# NOTICE OF DECISION

**PARTITION CASE NO.: PAR18-04**

**IN THE MATTER OF THE  
TENTATIVE APPROVAL OF  
PARTITION PLAT NO. 18-04;  
3045 PARK AVENUE NE**

**FINDINGS AND ORDER**

UTILITY PLAN	UT-1
SCALE: 1" = 10'	
PROJECT NO: 15-96	
TOTAL SHEETS: 9

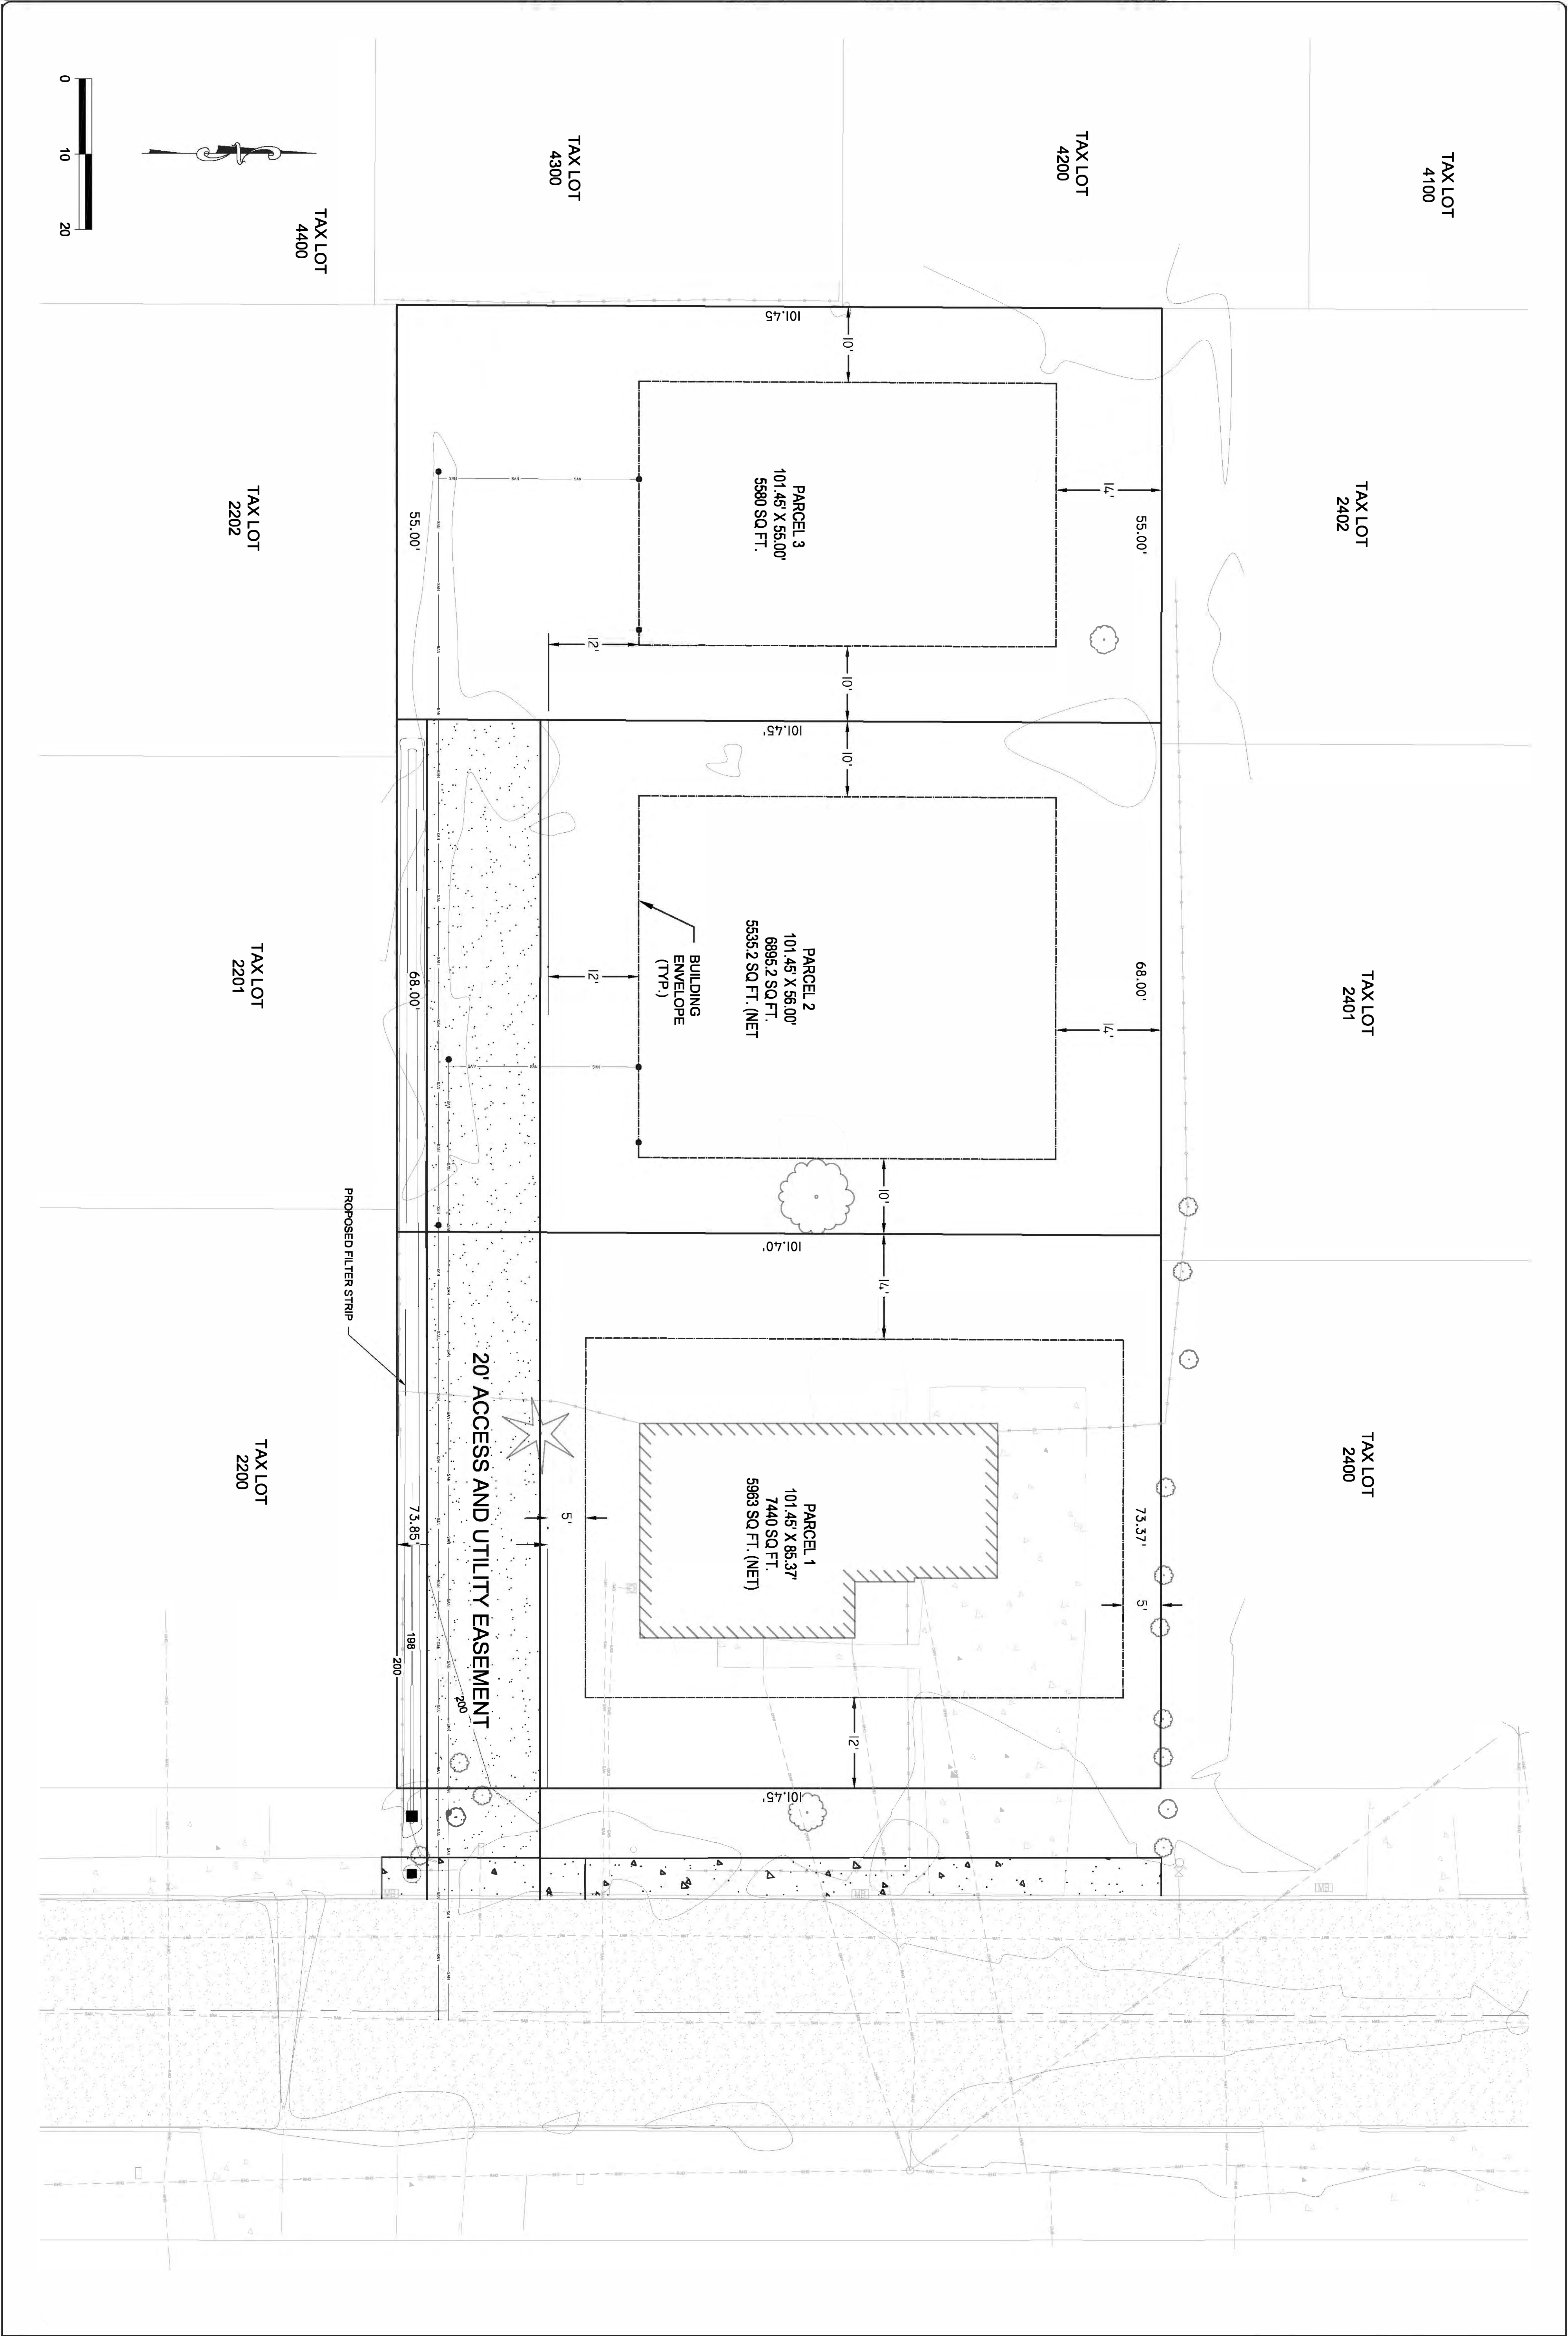
**Finding:** The subject property is within the Urban Service Area. Public Works Department staff reviewed the proposal and determined that water and sewer infrastructure is available along the perimeter of the site and appears to be adequate to serve the property as shown on the applicant's preliminary partition plan. As specified in the conditions of approval, private water, sewer, and storm services shall be constructed to serve each parcel as a condition of plat approval.

The proposed development is subject to SRC Chapter 71 and the revised PWDS as adopted in Administrative Rule 109, Division 004. To demonstrate the proposed parcels can meet the PWDS, the applicant shall submit a tentative stormwater design prior to final plat approval. For a tentative stormwater design, the applicant shall submit infiltration test results, the Simplified Method Form or Engineering Method Report as applicable, and a preliminary site plan showing the building envelope and tentative location of stormwater facilities. In order to ensure that stormwater systems within the proposed partition meet the requirements of SRC Chapter 71, the following condition shall apply:

- Condition 4:** The stormwater system shall be tentatively designed to accommodate future impervious surfaces. Construct stormwater facilities that are proposed in the public right-of-way or that serve more than one parcel.

- Condition 5:** Construct sewer services that are proposed in the public right-of-way.
- Condition 6:** Obtain permits for installation of water services to serve Parcel 2.
